ORDINANCE NO. 2017-39

AN ORDINANCE OF THE CITY OF WYLIE, TEXAS, REPEALING ORDINANCE NO. 2012-38; ADOPTING THE 2015 EDITION OF THE INTERNATIONAL RESIDENTIAL CODE, SAVE AND EXCEPT THE DELETIONS AND AMENDMENTS SET FORTH HEREIN; PROVIDING FOR A PENALTY FOR THE VIOLATION OF THIS ORDINANCE; PROVIDING FOR REPEALING, SAVINGS AND SEVERABILITY CLAUSES; PROVIDING FOR AN EFFECTIVE DATE OF THIS ORDINANCE; AND PROVIDING FOR THE PUBLICATION OF THE CAPTION HEREOF.

Exhibit A

Recommended Amendments to the 2015 International Residential Code North Central Texas Council of Governments Region

****Figure R602.6.1; delete the figure and insert the following figure:**

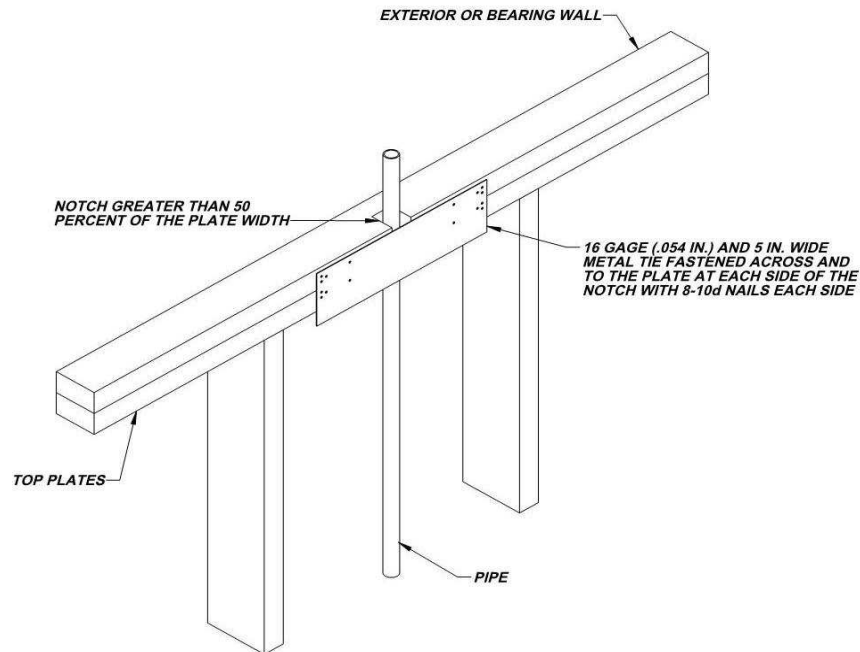
****Section R602.6.1; amend the following:**

R602.6.1 Drilling and notching of top plate. When piping or ductwork is placed in or partly in an exterior wall or interior load-bearing wall, necessitating cutting, drilling or notching of the top plate by more than 50 percent of its width, a galvanized metal tie not less than 0.054 inch thick (1.37 mm) (16 Ga) and 5 inches (127 mm) wide shall be fastened across and to the plate at each side of the opening with not less than eight 10d (0.148 inch diameter) having a minimum length of 1 ½ inches (38 mm) at each side or equivalent. Fasteners will be offset to prevent splitting of the top plate material. The metal tie must extend a minimum of 6 inches past the opening. See figure R602.6.1. {remainder unchanged}

(Amendment to 2012 IRC carried forward to 2015 IRC also provides additional assurance of maintaining the integrity of the framing by spreading the nailing pattern.)
